RE: Mission Rise PUD

Enclosed please find responses to Staff's comments below in bold. The following items are resubmitted in response to Staff's comments:

1. Conceptual Land Use Plan
2. Developer's Agreement
3. Traffic Impact Analysis (to be provided 8/29)

PARKS & TRAILS PROGRAM

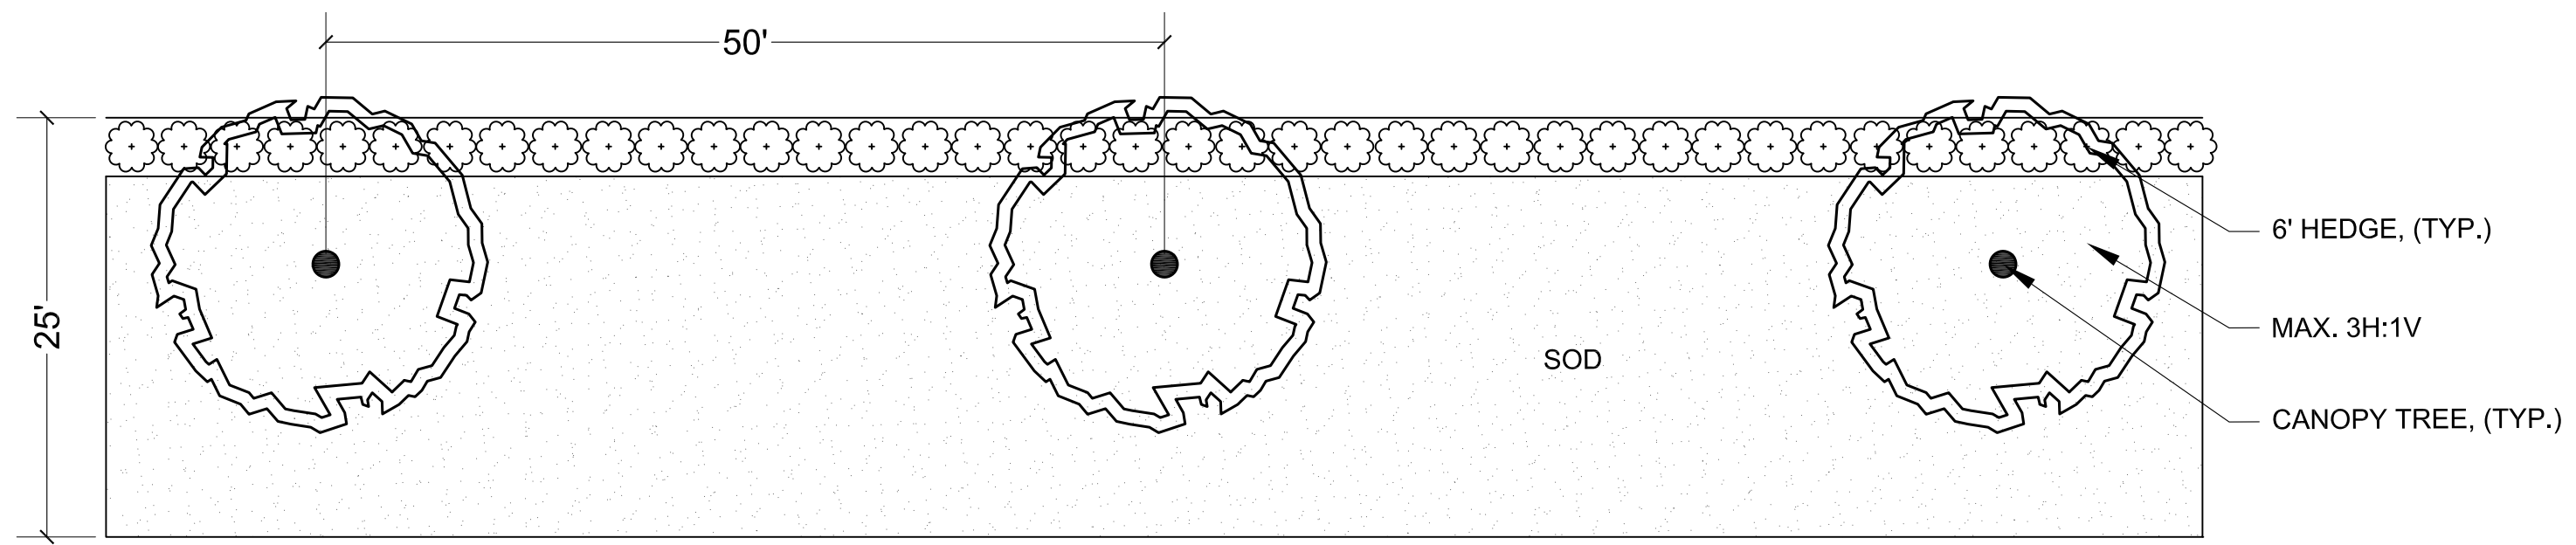
2. The plan could take better advantage of the terrain by locating the multi-use trail outside of the collector road right-of-way when possible. This placement will open ROW the door for consideration of the trail as a component of the non-residential area requirement.

10. The parcel has an opportunity to create a significant park area in the open space adjacent to Wetland Area 1 and link with bicycle and pedestrian trails.

12. The civic use parcel needs to be fully integrated into the project design. As shown there is no internal access to the parcel, and there is no assurance that access can be provided from SR 19.

RESPONSE: The multiuse trail design has been updated to locate the trail outside of the Collector Road ROW.

RESPONSE: Acknowledged. Further detail on the multiuse trail and park system has been provided on Sheet 3.

RESPONSE: Vehicular access from Revels Road to the Civic Site (trail head) has been demonstrated on the Conceptual Land Use Plan, Sheet 3.

SPINE ROAD
90' ROW WITH BIKE LANE & 12' MULTIMODAL TRAIL

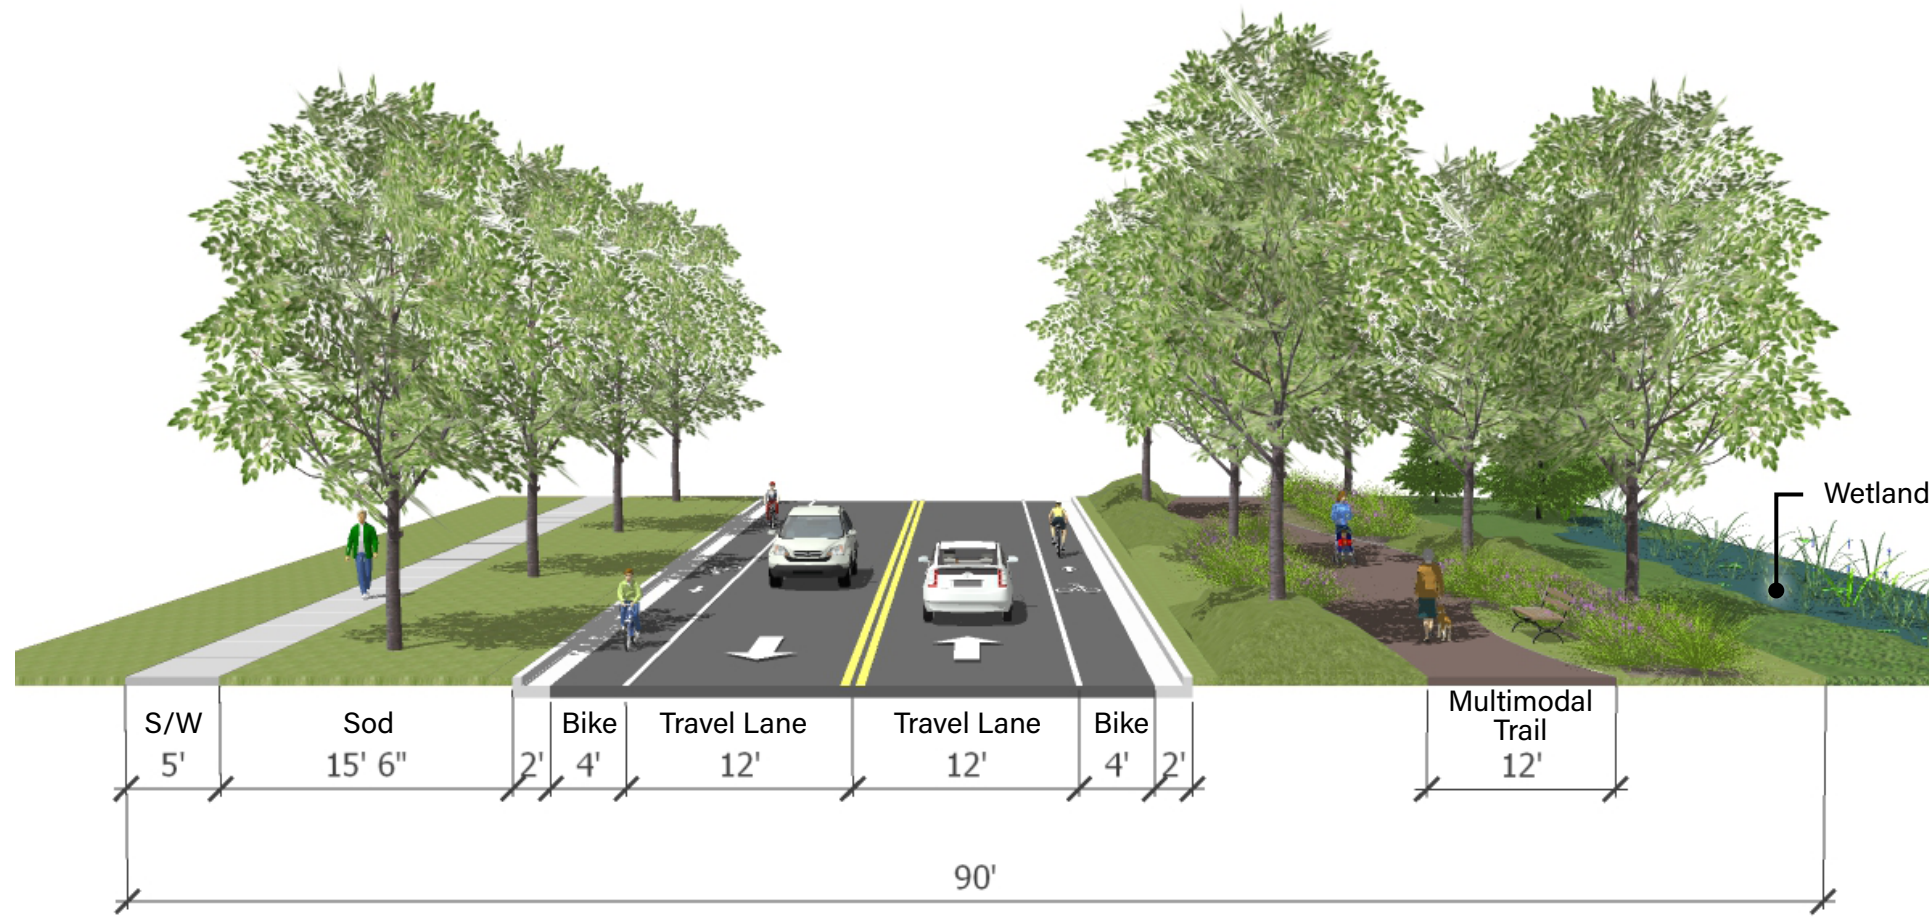
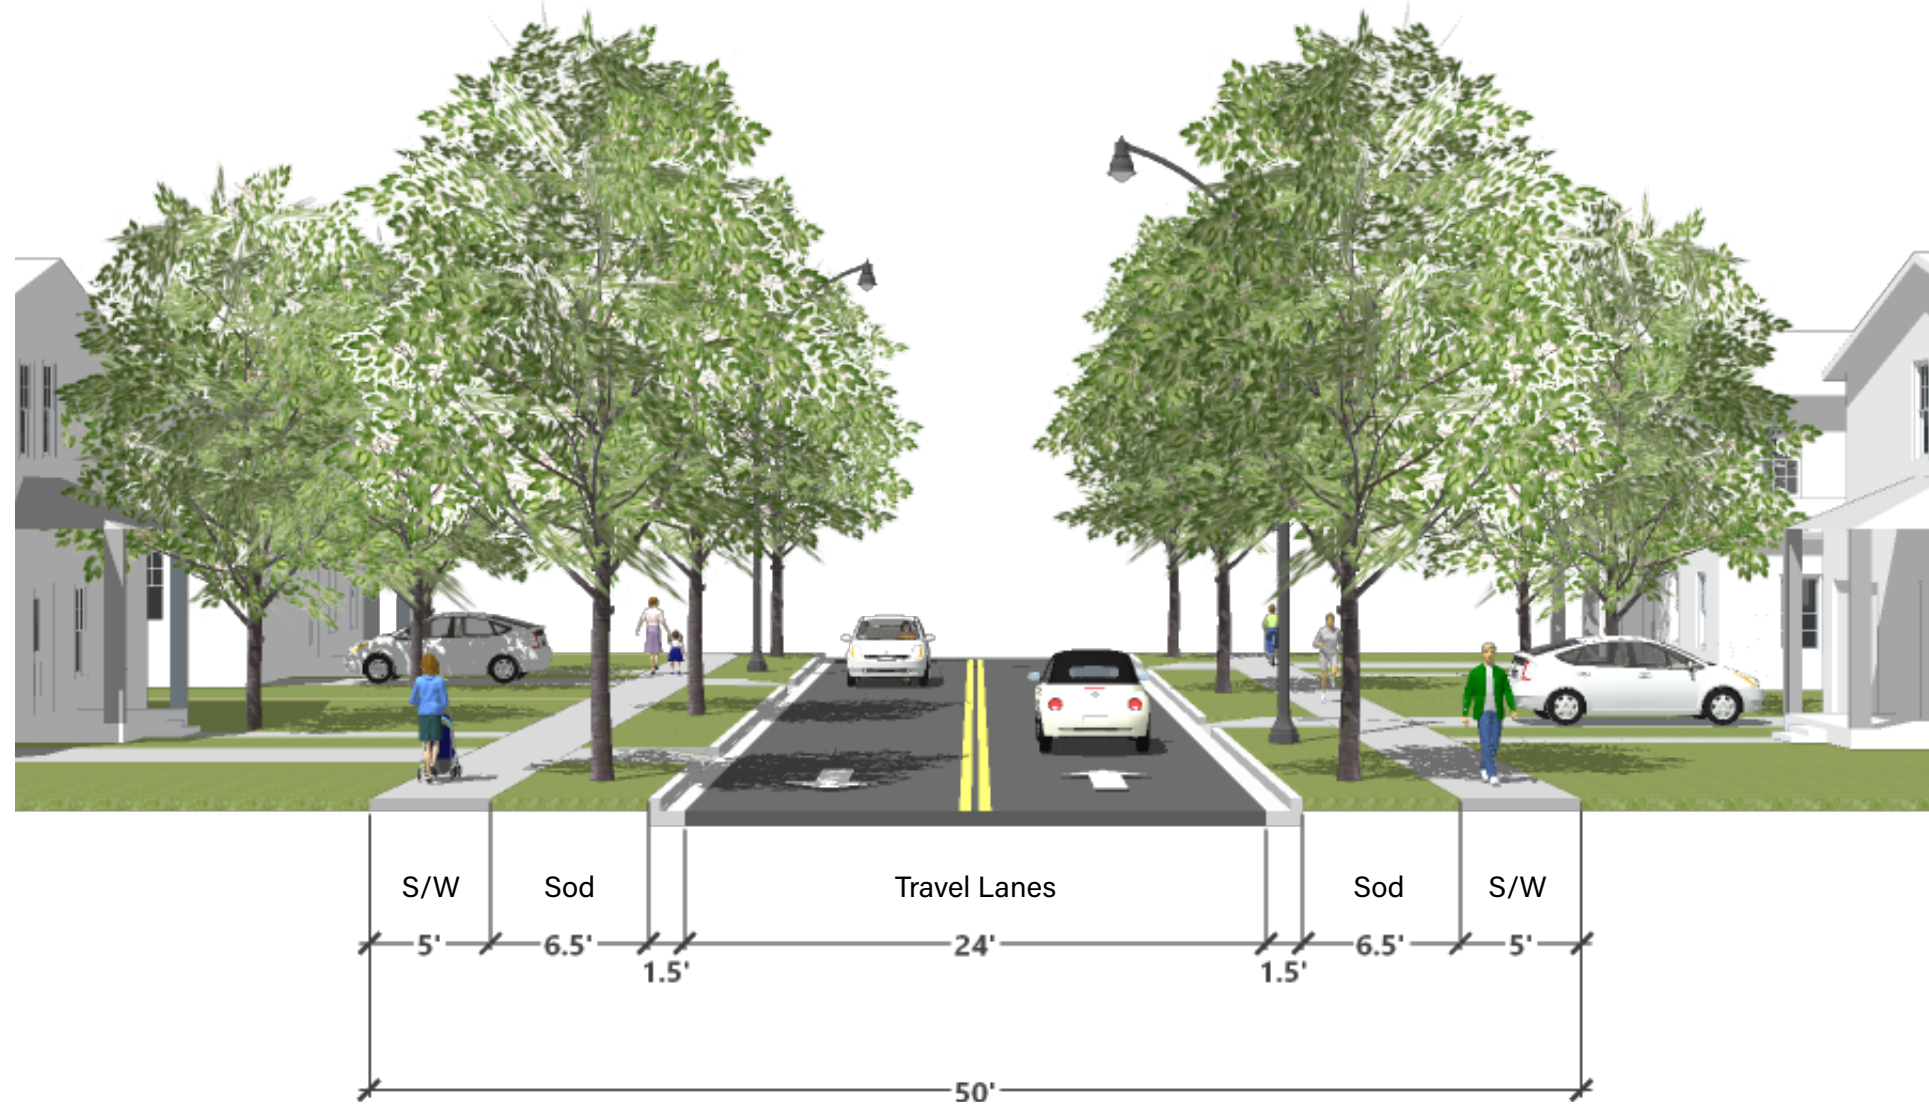
5. The design of the major collector needs to plan for a median and turn lanes at intersections. The two cross-section provided do not include a landscaped median area. Where properties have direct access from the collector road, periodic openings can be provided

2. The main N-S spine road and realigned Revels Road should be designed using Option 1, not Option 2. They should not have driveway connections or on-street parking. They should have full pedestrian accommodation including the multi-use trail and raised crosswalks/speed tables at key points along its length connecting the trail and sidewalks to amenity, open space, and park areas.

2. Section 1. (j) Transportation, Streets and Sidewalks: Revels Road and the Spine Road must have a minimum 90-foot right-of-way, 2' curb and gutter, and a minimum 32-foot-wide pavement with 12-foot travel lanes and 4' curb lanes.

RESPONSE: As discussed at the DRC meeting on August 10, 2023, the Collector Road cross-section is proposed without a median, but will include 4' bike lanes as well as a 12' multi-use trail.

RESPONSE: Acknowledged, the revised Conceptual Land Use Plan proposes Option 1 for the Collector Roadway design. This has further been updated to increase the width of the multiuse trail to 12'.

RESPONSE: Please see the revised Development Agreement.

NEIGHBORHOOD ROAD
OPTION 1 - 50' ROW

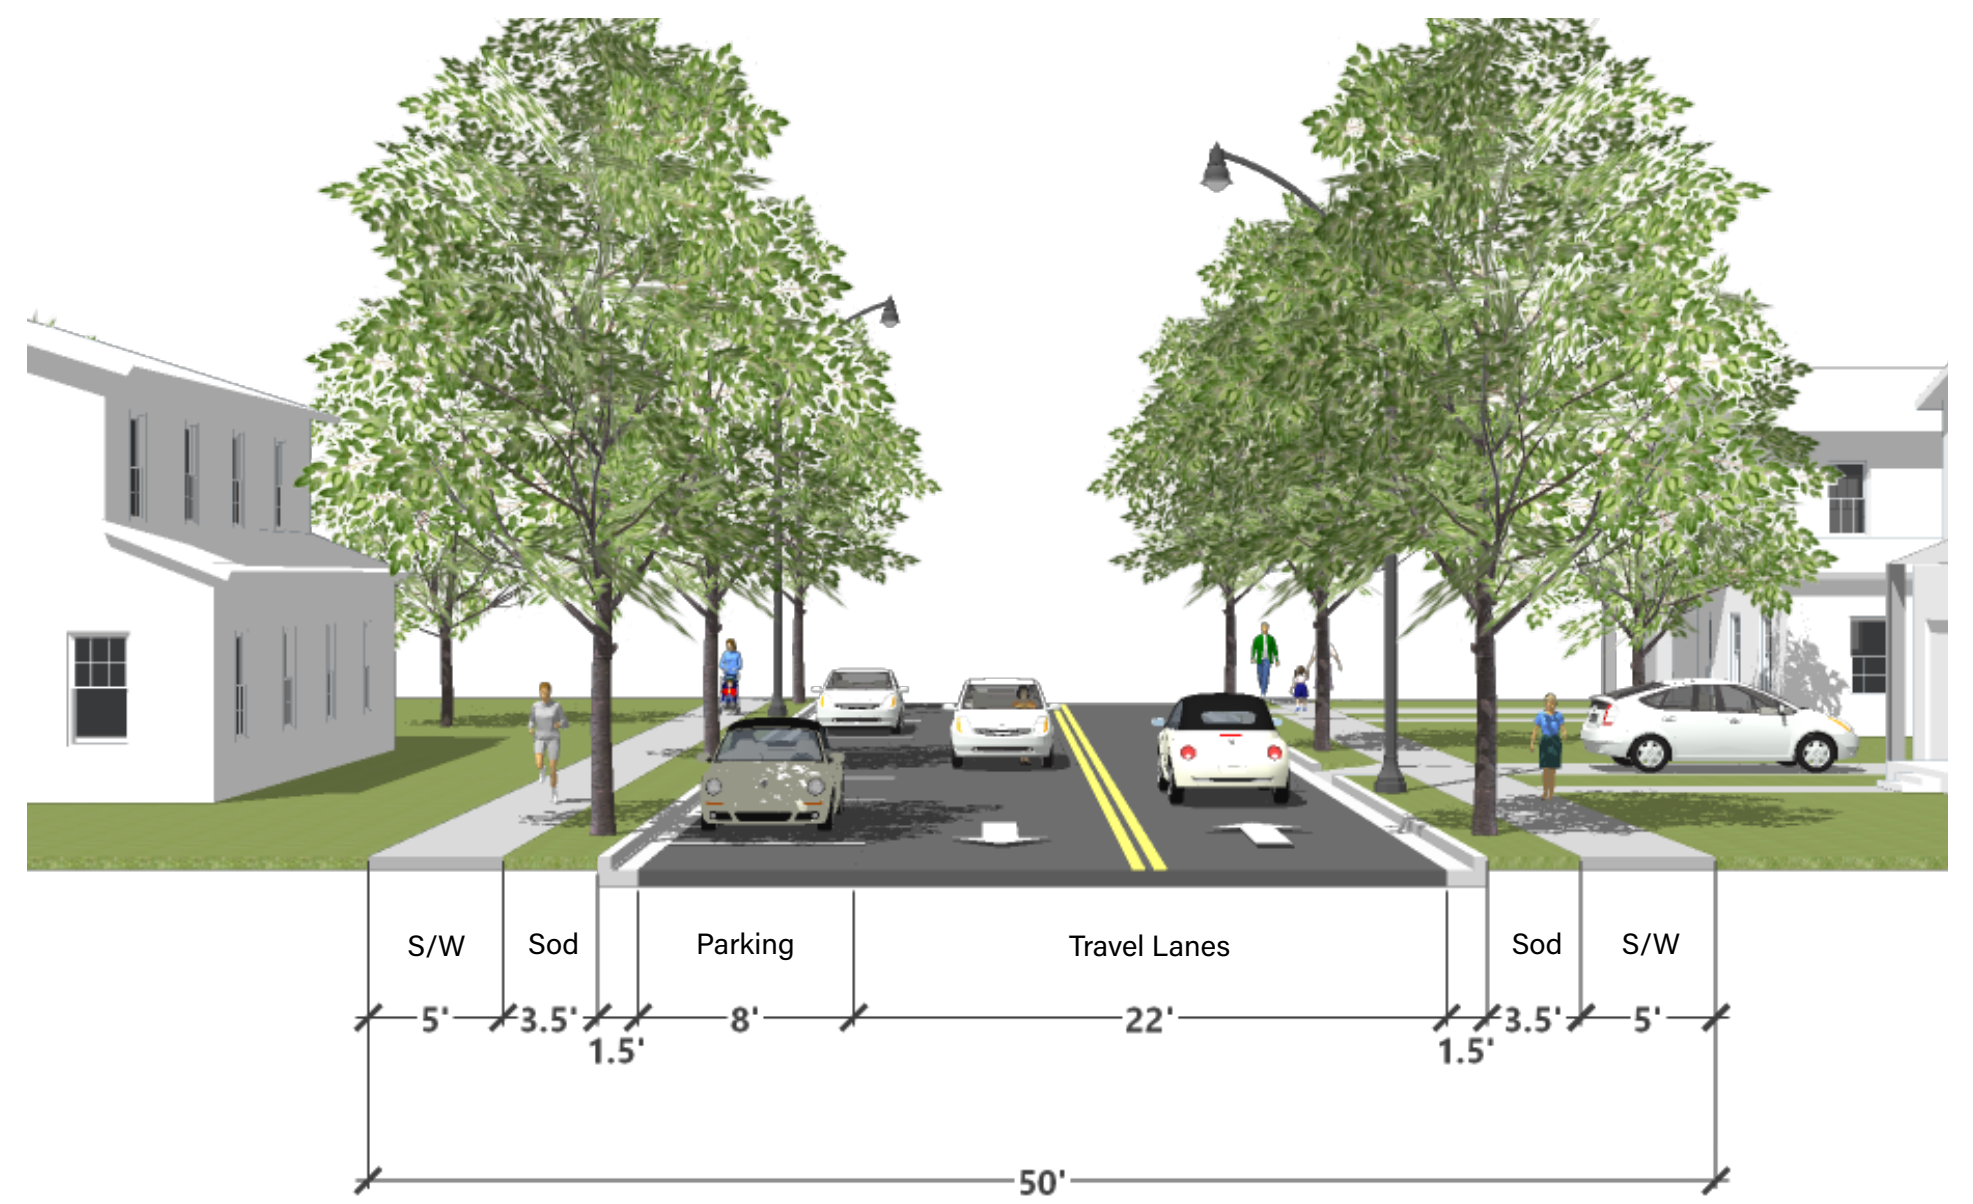
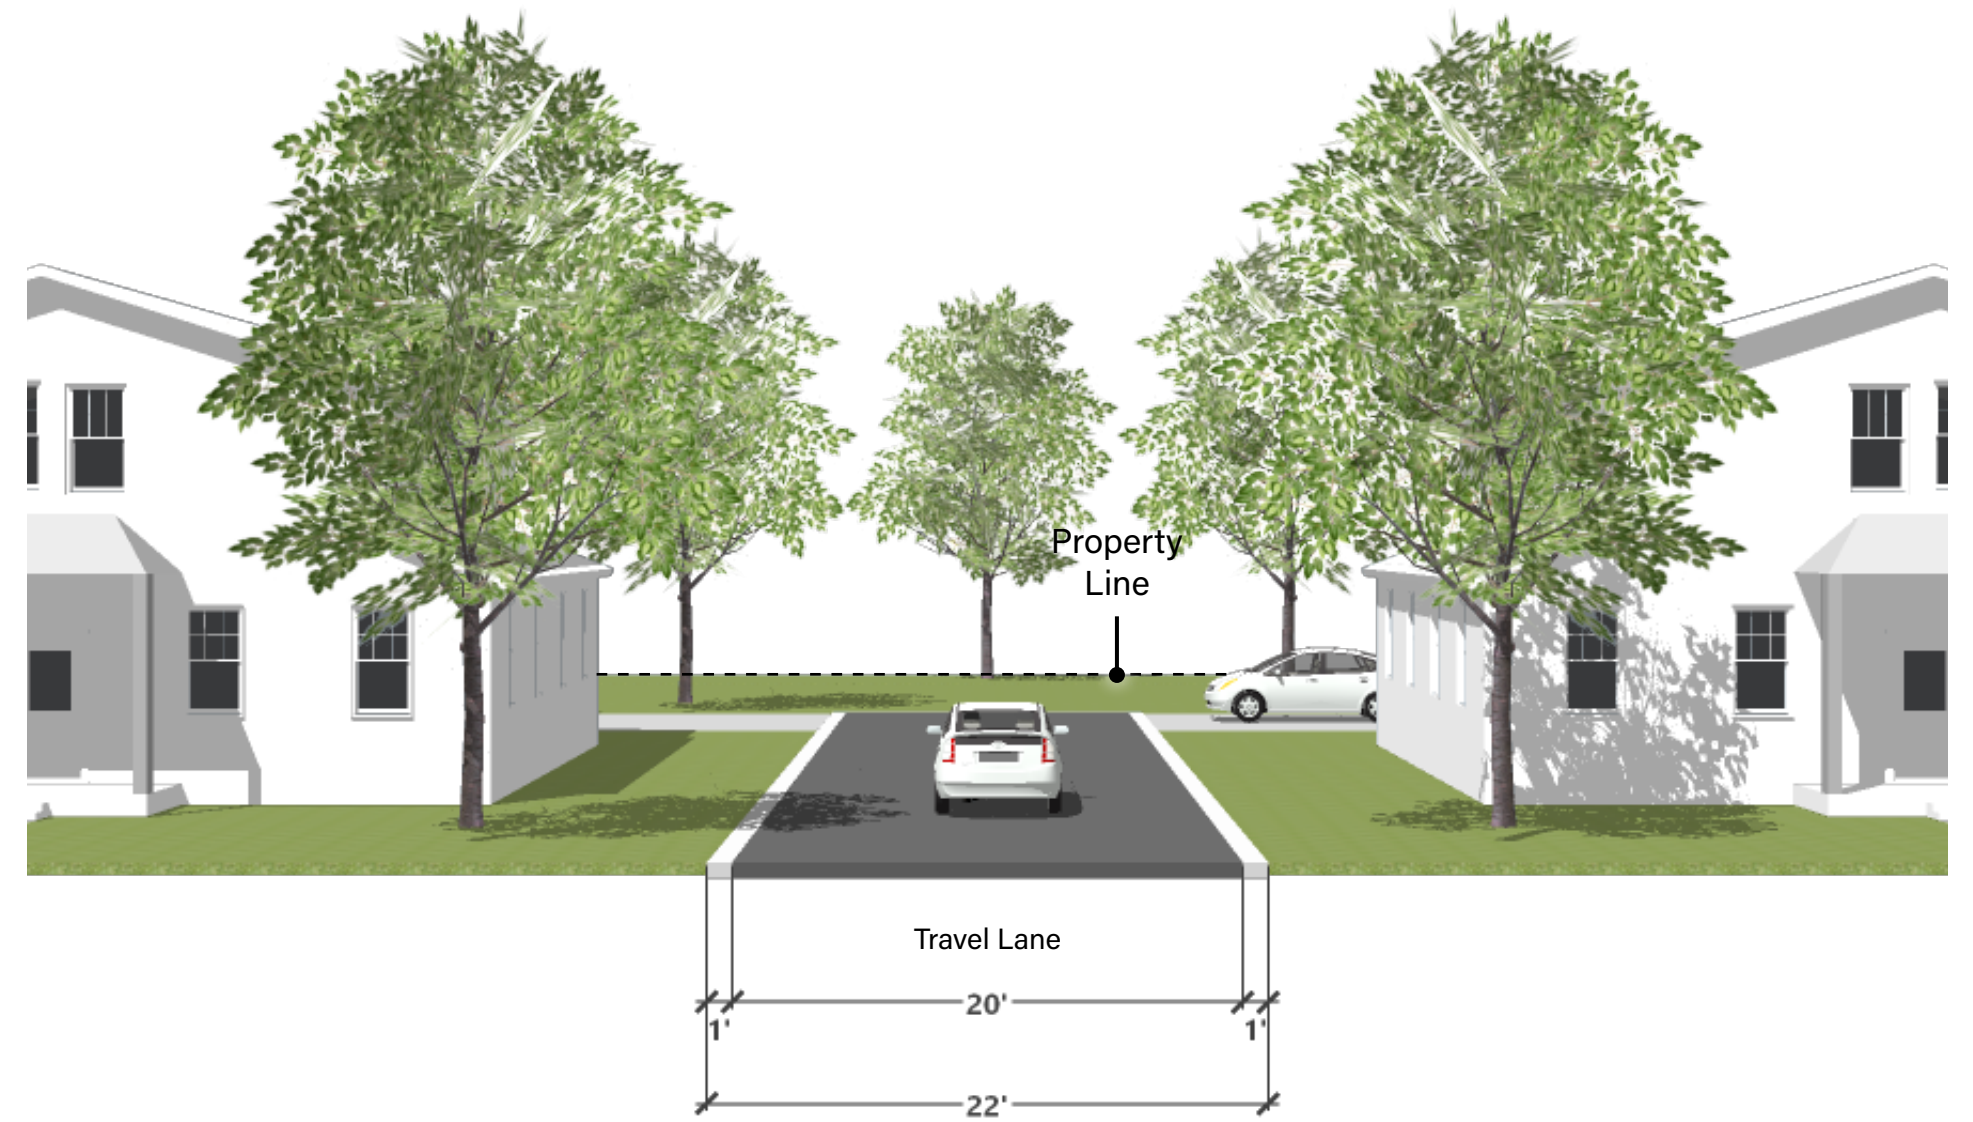
3. The neighborhood roads should meet the town's current road standard..

4. For the sections of neighborhood roads with end-cap parallel parking, a wider right-of-way should be provided to accommodate the additional pavement..

RESPONSE: The proposed roadway sections are consistent with the details provided in Table 8.02.02 of the LDC.

RESPONSE: The proposed roadway sections are consistent with the details provided in Table 8.02.02 of the LDC.
